Craig 9 Ranches Master Drainage Study

CITY OF LAS VEGAS		DATE:
INTER-OFFICE MEMORANDUM		October 27, 2016
TO: Land Development Services Department of Building & Safety		FROM: Albert Sung, P.E. Flood Control Project Engineer Department of Public Works
SUBJECT:	Drainage Study for:	COPIES TO:
	Craig & Rancho Master Drainage Study	Lochsa Engineering
Cross Streets:	SEC of Craig Road & Rancho Drive	Pre Rancho Craig LLC
File Number:	F:\Depot\DSMemos\DS4824B.doc	Bart Anderson, P.E., DevCo
Parcel Number:	138-02-713-002	CCRFCFCD
Zoning Action:	N/A	NDOT
FEMA Flood Zone	YES NO X	
Proposed Storm Drain	YES NO X

**DISTRICT CONCURRENCE: CRAIG & RANCHO MASTER DRAINAGE STUDY
(DS4824B) (RFCD No. 16-9754)**

Subject: Addendum to Craig & Rancho Master Drainage Study
City of Las Vegas DS4824
Lochsa Engineering Project Number: 161051

SHEET No.
DR2

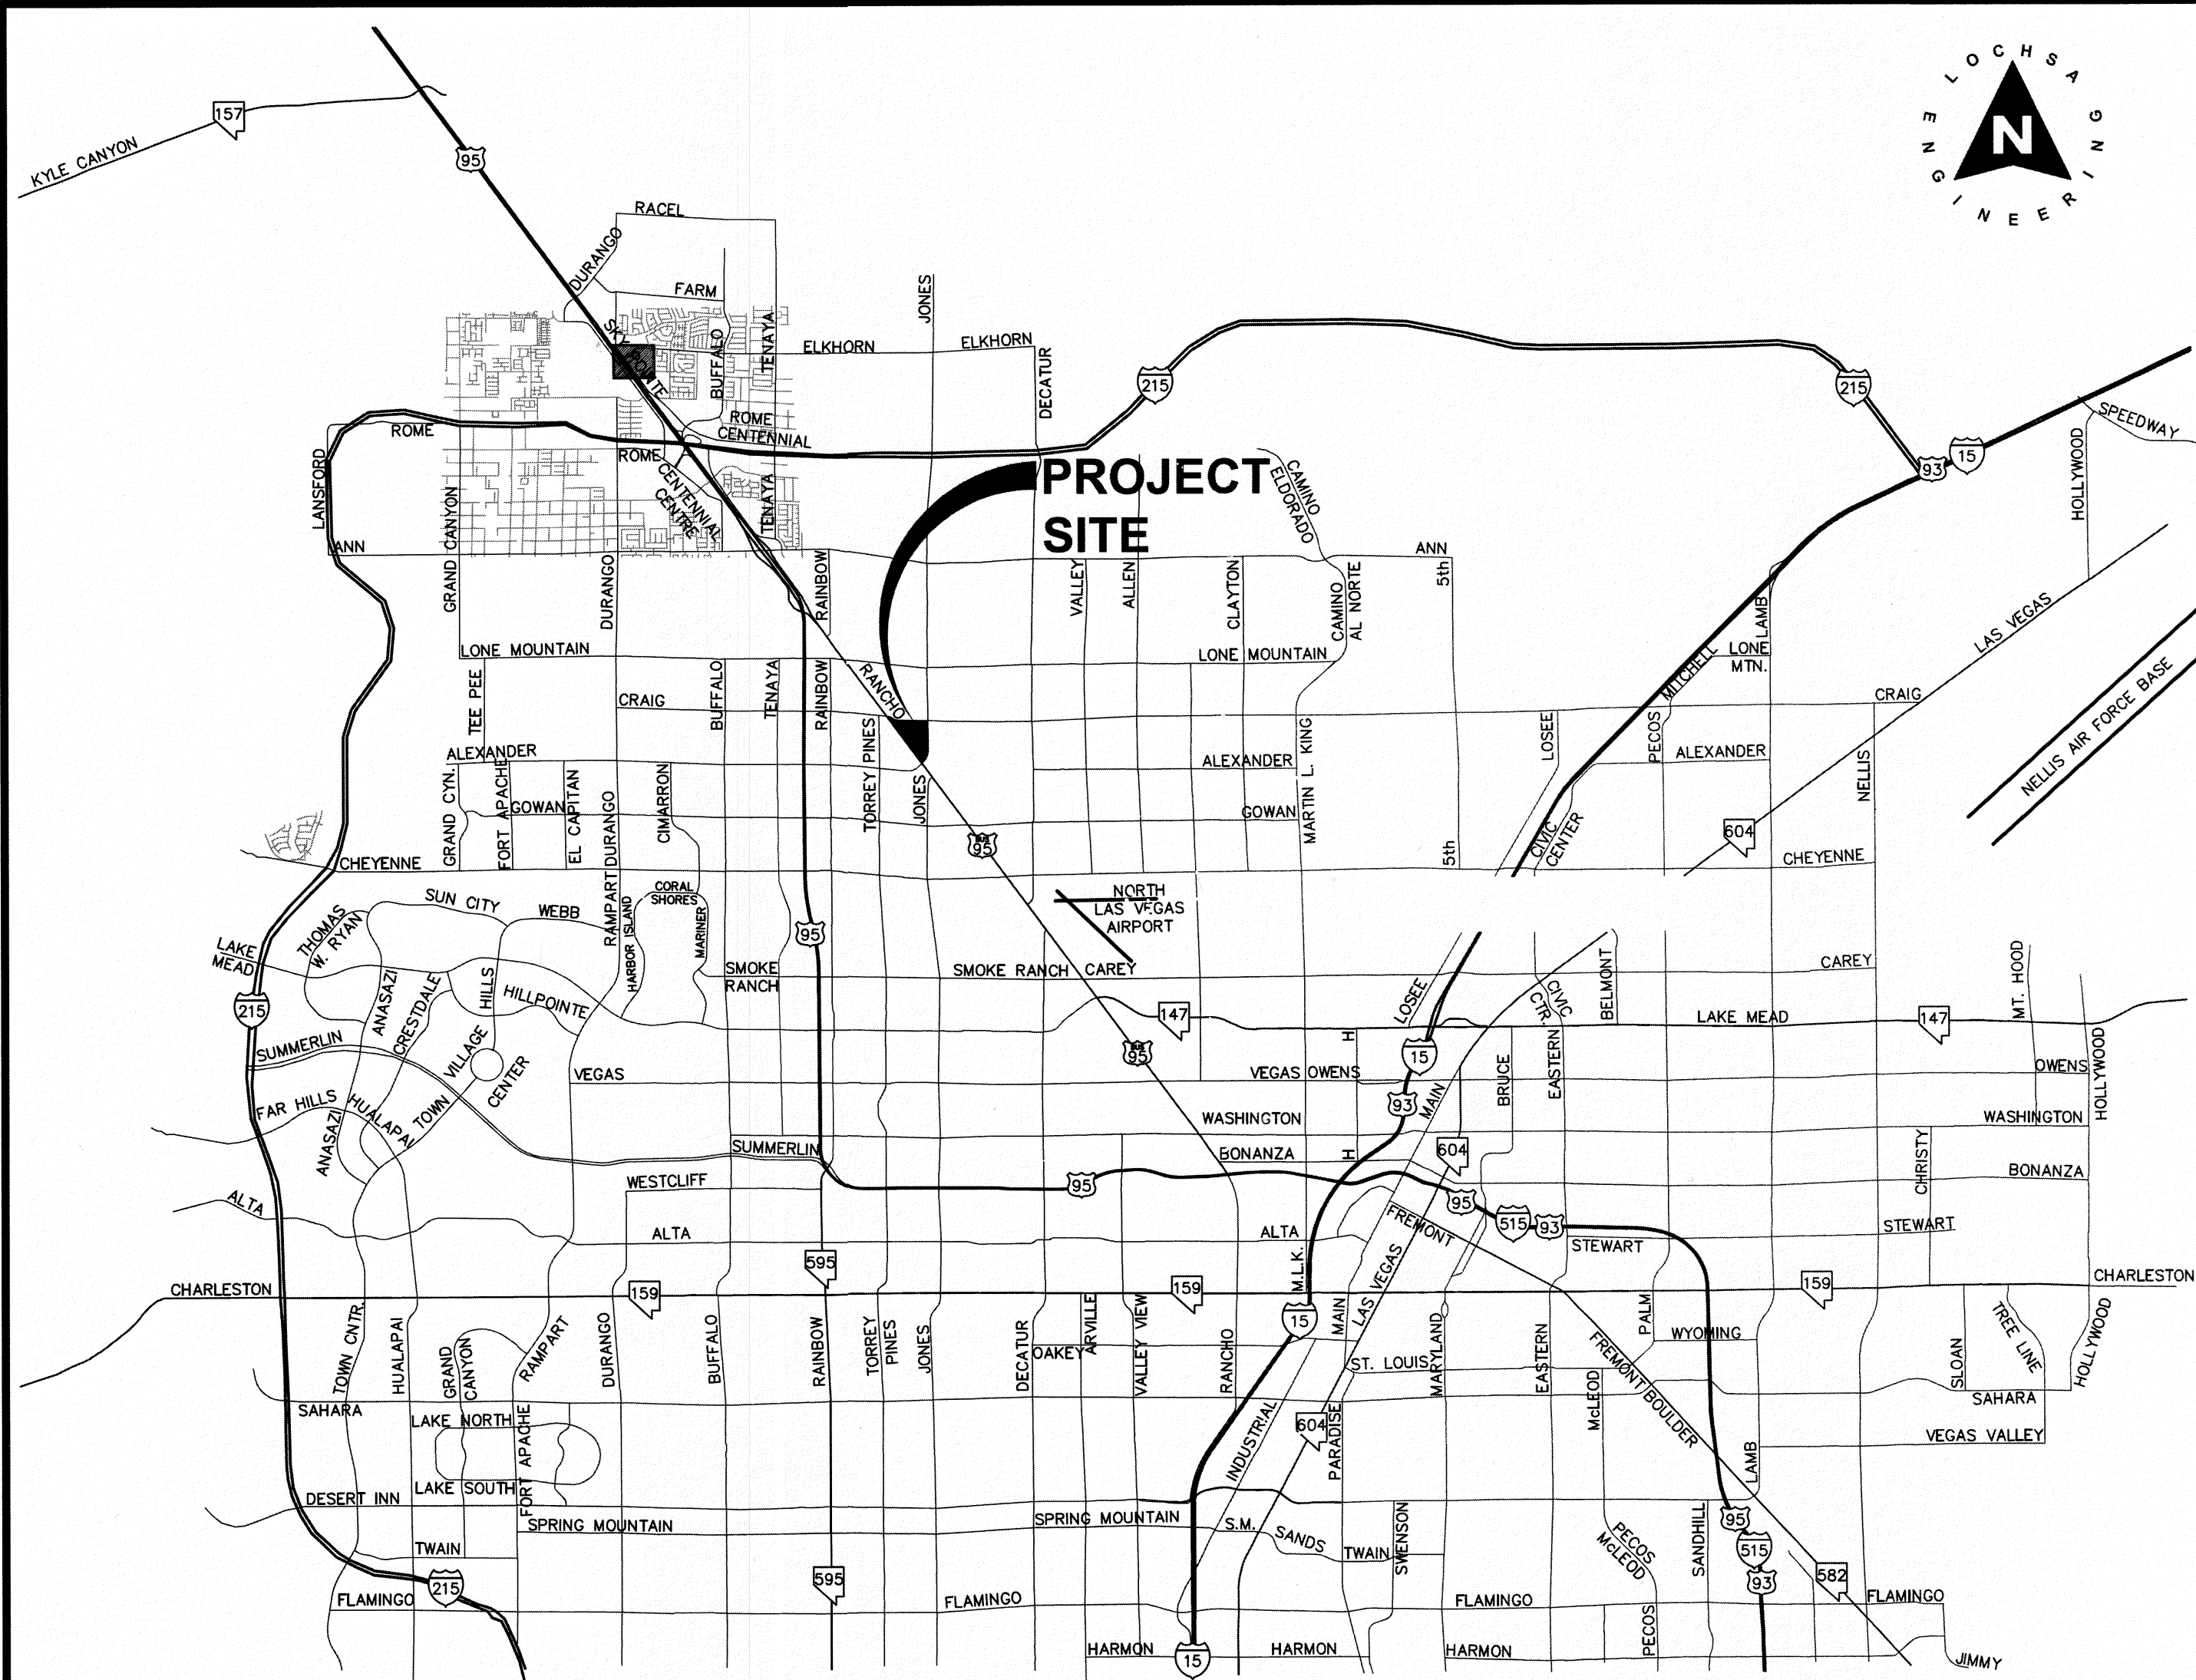
5. **Sheet DR2:** The 10-yr/25-yr/100-yr flows labeled for Subbasin "ND2" was incorrect. Revise to show 26/34/46 cfs in the next submittal.

- Sheet DR2:** The 10-yr/25-yr/100-yr flows labeled for Subbasin "ND2" was incorrect. Revise to show 26/34/46 cfs in the next submittal.

Response 5: Drainage exhibit DR2 has been revised to reflect the correct runoff flows for basin ND2(26/34/46cfs, Q10/Q25/Q100).
